UNITED STATES
NUCLEAR REGULATORY COMMISSION
WASHINGTON, D.C. 20555-0001

SUBJECT: CALVERT CLIFFS NUCLEAR POWER PLANT UNITS 1 AND 2 – FLOOD
HAZARD MITIGATION STRATEGIES ASSESSMENT (CAC NOS. MF7908 AND
MF7909)

STAFF ASSESSMENT BY THE OFFICE OF NUCLEAR REACTOR REGULATION
RELATED TO MITIGATION STRATEGIES FOR CALVERT CLIFFS NUCLEAR POWER
PLANT UNITS 1 AND 2 AS A RESULT OF
THE REEVALUATED FLOODING HAZARD NEAR-TERM TASK FORCE
RECOMMENDATION 2.1- FLOODING CAC NOS. MF7908 AND MF7909

Figure 3.1.1-1. Schematic of HEC-HMS model, taken from the Amended FHRR (Exelon, 2015).

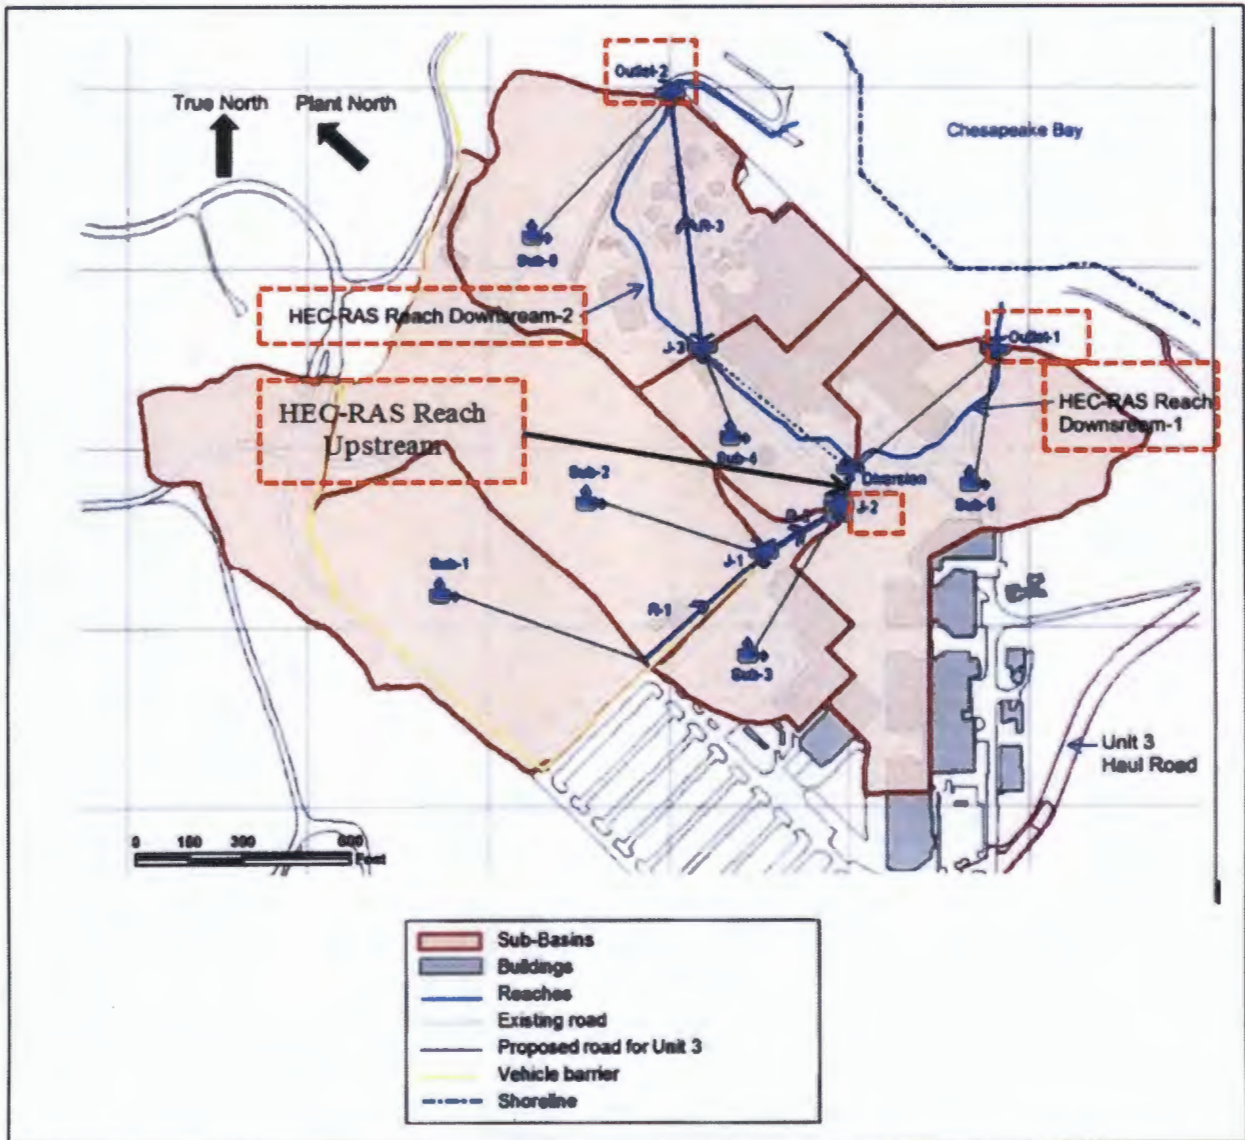
The licensee applied USACE-developed HEC-HMS and HEC-RAS models sequentially to evaluate the LIP flood hazard caused by a LIP flood-causing mechanism. They postulated a 6-hour ssPMP scenario as input to the Calvert Cliffs HEC-HMS model. That is, they distributed the 6-hour ssPMP value into 5-minute, 15-minute, 1-hour, 2-hour, 3-hour, and 6-hour intervals for input to the model (see Table 3.2.0-1). They used a front-peaking distribution in time. To set up the Calvert Cliffs HEC-HMS model, the licensee divided the onsite LIP basin into 6 subbasins and then linked the subbasins by channels as shown in Figure 3.1.1-1.

Figure 3.1.1-2. Schematic of the HEC-RAS hydraulic model for simulating the LIP flood-causing mechanism.

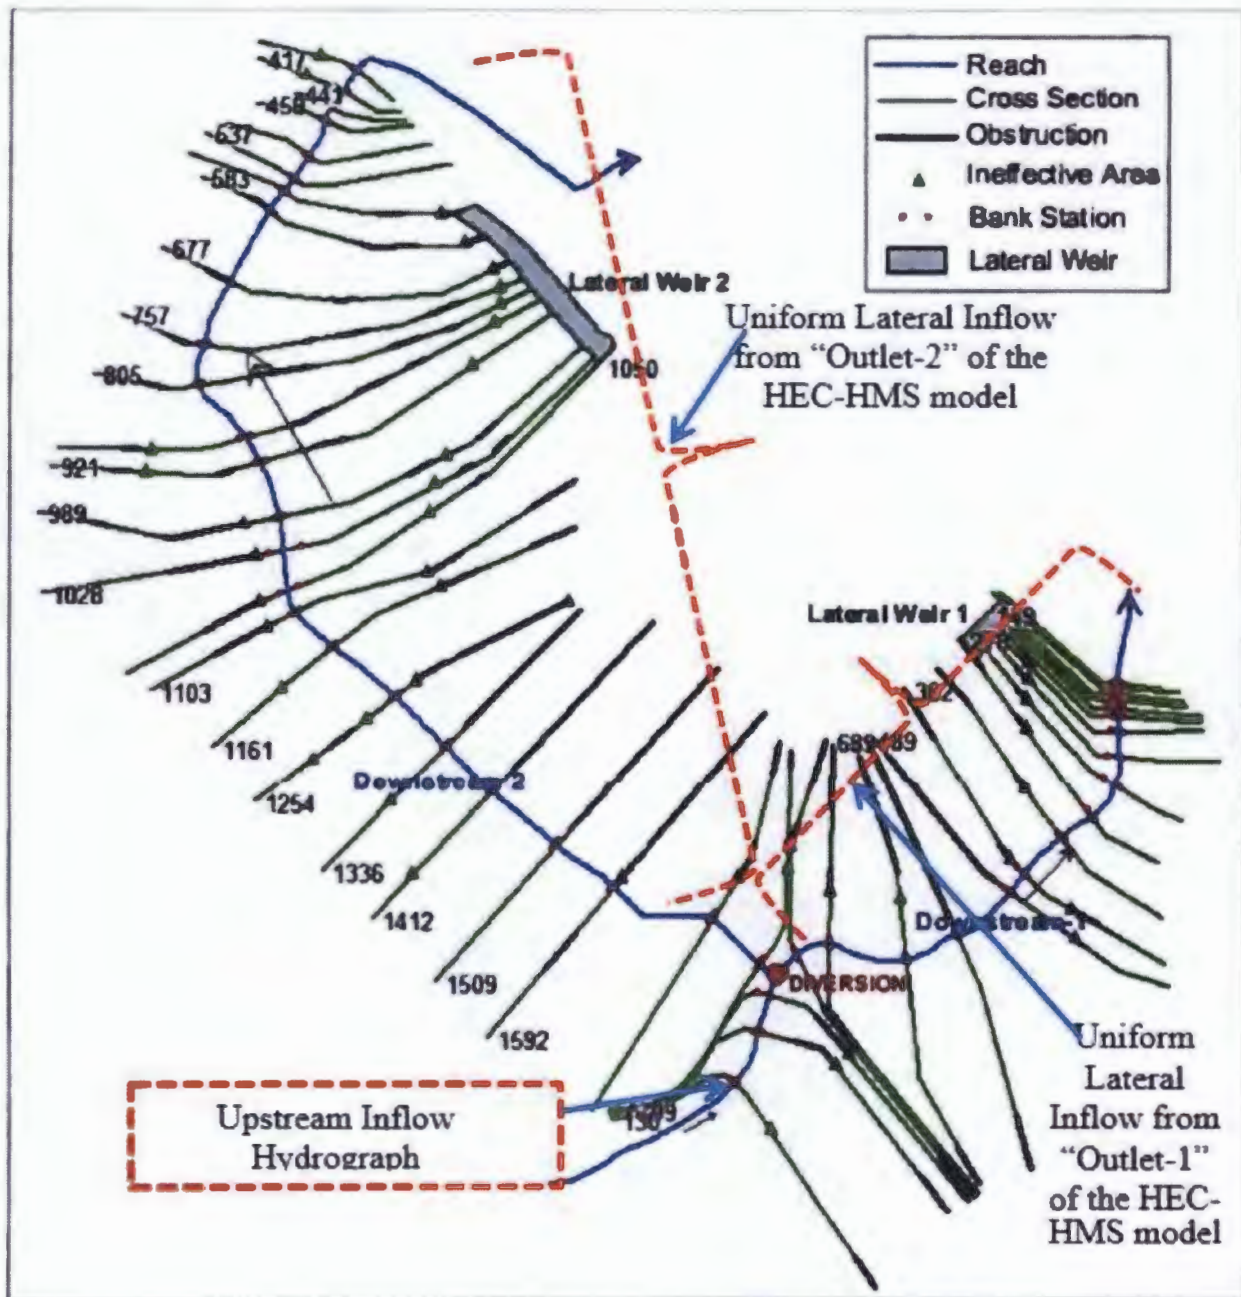
As described in its original FHRR, the licensee used the HEC-RAS model to route flood elevations at the Calvert Cliffs Units 1 and 2 power block area. The main features of the HEC-RAS are onsite drainage channels and cross-sections (see Figure 3.1.1-2). The licensee used the simulated outflow flow hydrographs from the HEC-HMS at locations, "J-2", "Outlet-1", and "Outlet-2" as upstream inflows to channels in HEC-RAS.

Figure 3.1.2-3. Postulated PMH scenarios for (a) track direction (top) and (b) distance from the plant site to storm center (bottom) (from Exelon (2017)).

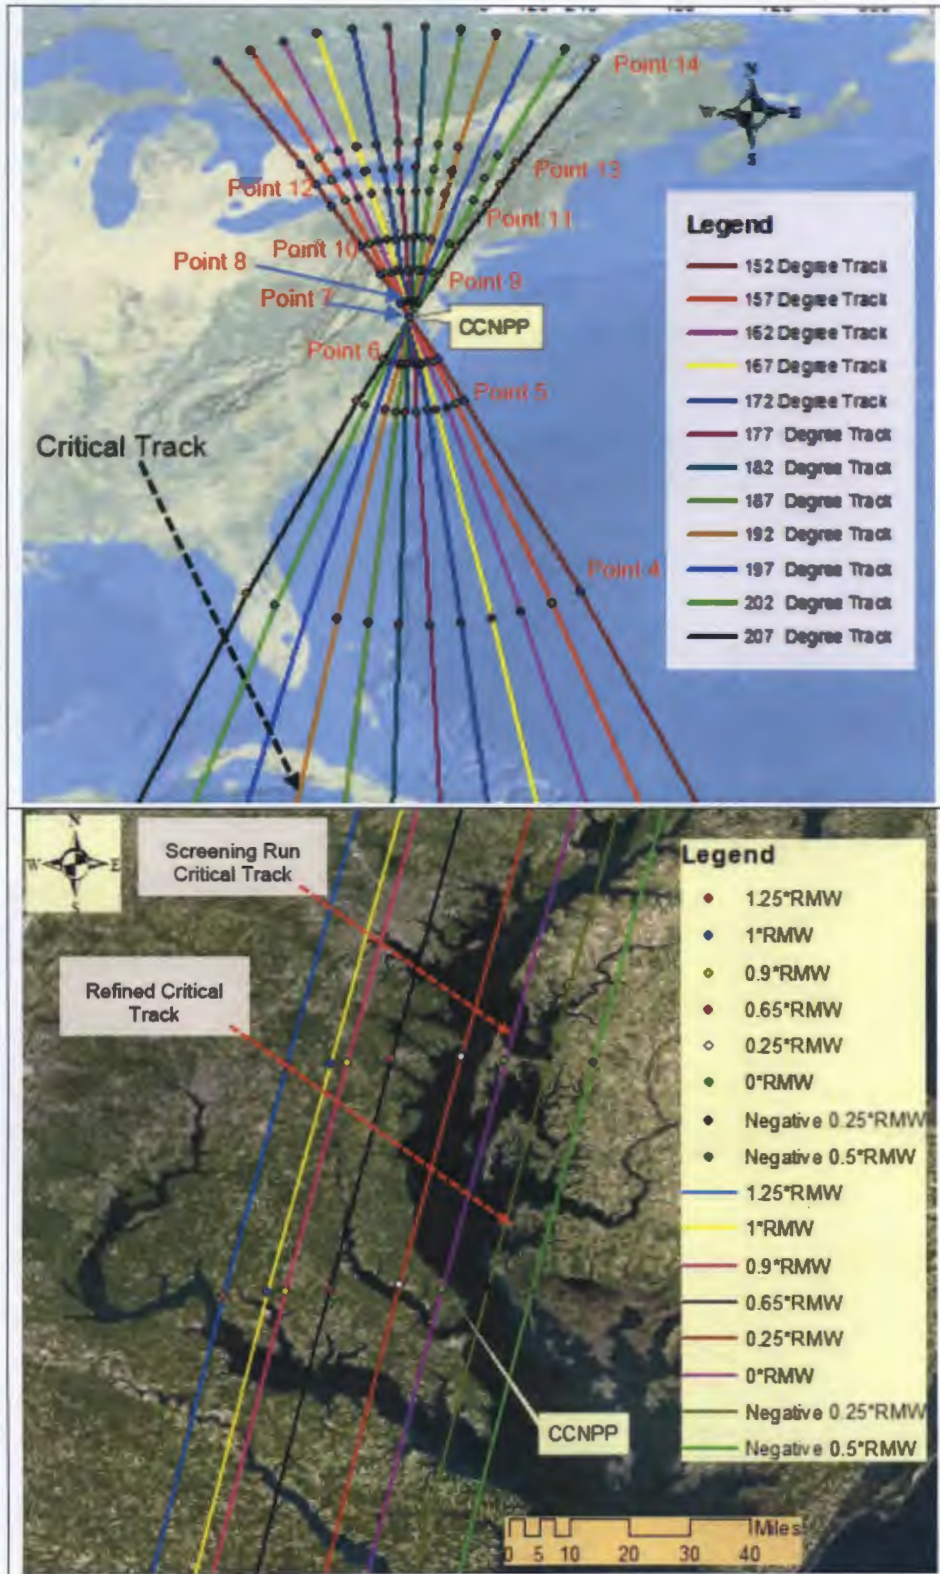
- i. Hold the pressure deficit of 123 milibar (mb) which is the maximum, and synchronize the timing of the storm surge with incoming high tide.
- ii. Simulate the Calvert Cliffs Delft 3D model with 10 track directions (152, 157, 162, 167, 172, 177, 182, 187, 192, and 197 degrees clockwise from the north) with an initial RMW of 26 nm, forward speed of 17 m/s, and center distance of zero from the plant site. From these sensitivity runs, the licensee identified the track direction of 192 degrees as it produces the maximum surge level (see Figures 3.1.2-3a and 3.1.2-4a).

- v. Simulate 8 center distances (1.25, 1.0, 0.65, 0.25, 0, -0.15, -0.5, -0.25 times RMW (see Figure 3.1.2-3b)), where positive value means storm center is shifted to the left from the site, while negative is to the right. The licensee selected -0.25 times RMW (0.25 times radii to the left) as an optimal (see Figures 3.1.2-3b and 3.1.2-4d).

Figure 3.1.2-4. Delft3D storm surge sensitivity for (a) track direction for top-left, (b) RMW for top-right (c) forward speed for bottom-left, and (d) storm track for bottom right (from Exelon(2017)).

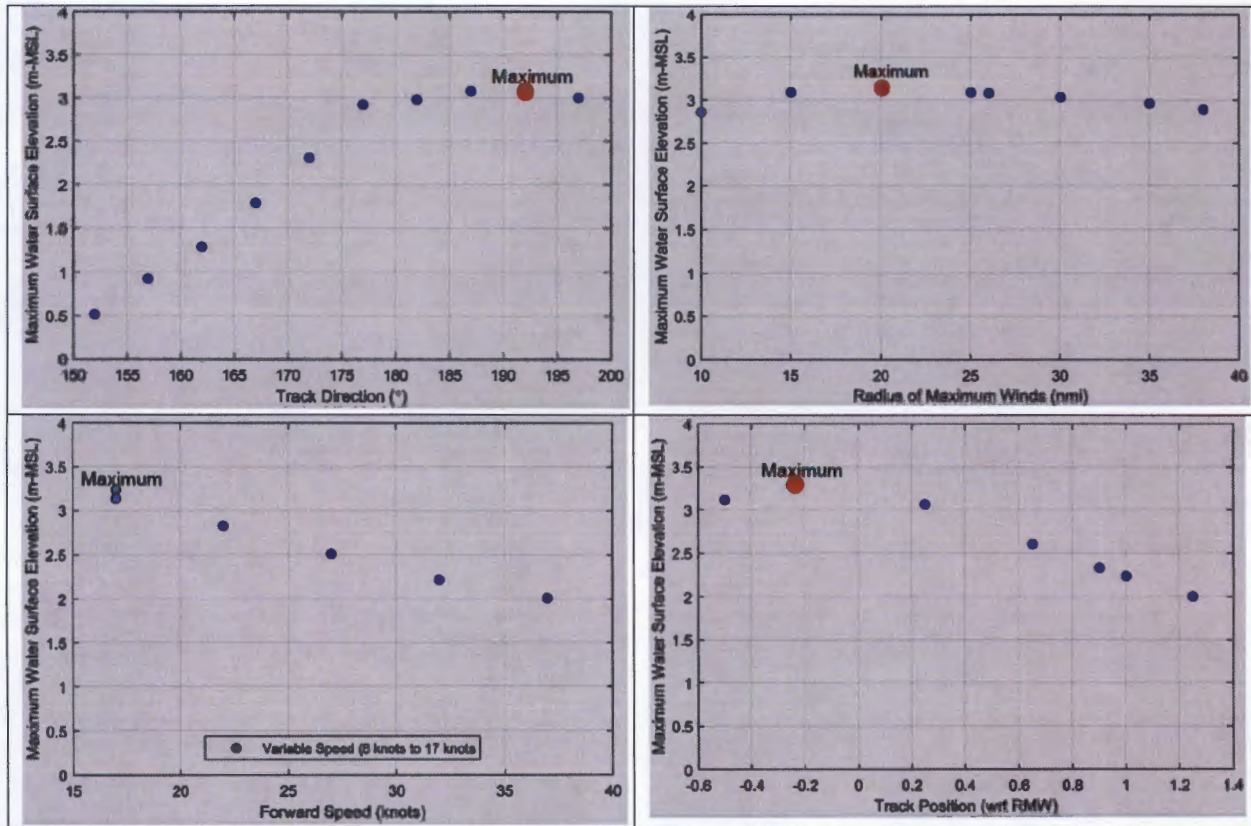
- iii. Simulate the model with 8 RMWs (10, 15, 20, 25, 26, 30, 35, 38 nautical miles (nm)) with the storm direction of 192 degree, forward speed of 17 m/s, and center distance of zero. The radius of maximum wind sensitivity was extended beyond the range presented in NWS 23 to determine if hurricanes with larger RMWs increase the surge level at the plant site. From these runs, the licensee determined an optimal RMW of 20 nm (see Figure 3.1.2-4b).

- iv. Simulate the model with 6 storm forward speeds (17, 22, 27, 32, 37, and variable speed of 8 and 17 knots (kt)) with the storm direction of 192 degree, RMW of 20 nm, and center distance of zero. The licensee-identified combined forward speeds of 8 kt before landing and 17 kt after landing turned out to be optimal (see Figure 3.1.2-4c).

Table 3.1.2-1 lists the licensee-provided optimal PMH parameter values from the resulting of the screening. Figure 3.1.2-4 displays the results of the sensitivity analysis, where each plot forms clear surge level peaking for most of the parameters. As the rates of changes at the peak are insignificant (e.g., mostly less than a foot), the staff determined the discrete parameter intervals used in the licensee's screening is acceptable without further refining the parameter values at finer discrete intervals. In particular, the staff noted onsite surge level is less sensitive to the change of RMW values compared to those at open coastal sites. The staff believes this is due to the breaking and attenuation of offshore surge and wave, as the plant site is located approximately 80 miles inside from the mouth of the Chesapeake Bay.

The staff also noted the licensee's selection of 20 nm RMW storm is based on a single "base" track that goes over site, even though it is within the range provided by NWS 23. That is, the sensitivity to RMW parameter was not checked for multiple storm tracks, angles, and landing locations. For example, the licensee settled on the 20 nm RMW value with a simple track (landfall and angle) that may not produce the maximum water level at the plant site. The staff also recognized the screening could be improved further by refining the PMH parameter values, such as using RMW values at the 1nm resolution or track positions at the finer (e.g., 0.1 times RMW) resolution. These refinements would end up a higher surge level estimates than the ones presented by the licensee in the amended FHRR. To resolve this issue, the staff found from Figure 3.1.2-4 that the change of surge level at or near optimal RMW (e.g., 20 nm) is small for those initial "base" runs (e.g., much less than one foot per discrete interval tried), and that the same is true for other PMH parameters. Therefore, the staff determined the result of the licensee's screening is acceptable without further refining the parameter intervals. In all, the staff concludes the screening process to obtain site-specific PMH parameters is reasonable and the resulting PMH parameters are acceptable for use in the MSA as the licensee followed a hierarchical approach recommended by the guideline provided in NUREG/CR-7046 Appendix E (NRC, 2011).

Figure 3.1.2-7. Cross Section Schematic of Wave Activity on Pump House at Calvert Cliffs Units I and 2 House (from the amended FHRR, Figure 2.4-32).

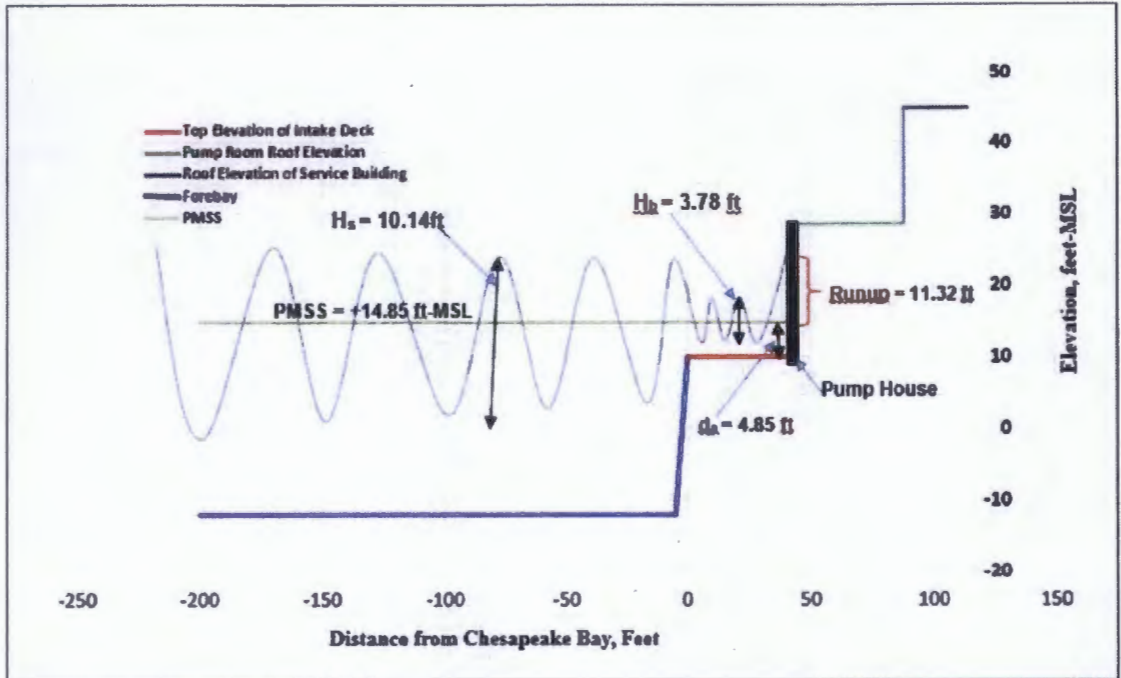
The licensee estimated storm surge-induced wave runup at the Units 1 and 2 Intake Structure (Exelon, 2015). The licensee assumed that runup occurs when wind-generated wave moves over the top of the intake deck and hits the front wall of the Intake (see Figure 3.1.2-7). They determined the controlling depth of water on the deck is 4.85 ft. The controlling depth limits the wave height over the deck as the break of large waves may occur in front of the deck. The licensee determined a maximum wave height after break is equal to 3.78 ft. using a depth limiting constant of 0.78 (Exelon, 2015). The licensee estimated runup values using the following two methods described in Army Corps of Engineering (USACE) Coastal Engineering Manual (CEM) (USACE, 2011):

For the equivalent slope method, the staff assumed the step-like intake deck cross section from the toe of the deck to intake wall is idealized as an impermeable slope. With the deck height of 10 ft. and length to the wave direction of 50 ft., the staff estimated an equivalent slope of 17.2 degree using the guideline provided by the CEM (USACE, 2011). The staff's independent calculations demonstrates that the licensee-estimated wave runup values are within the range of the staff's values even though the licensee used different runup conditions and exceedance probability level. Therefore, the staff concludes the licensee's runup estimate is acceptable for use in the MSA as they followed the guidelines provided by USACE (2011).
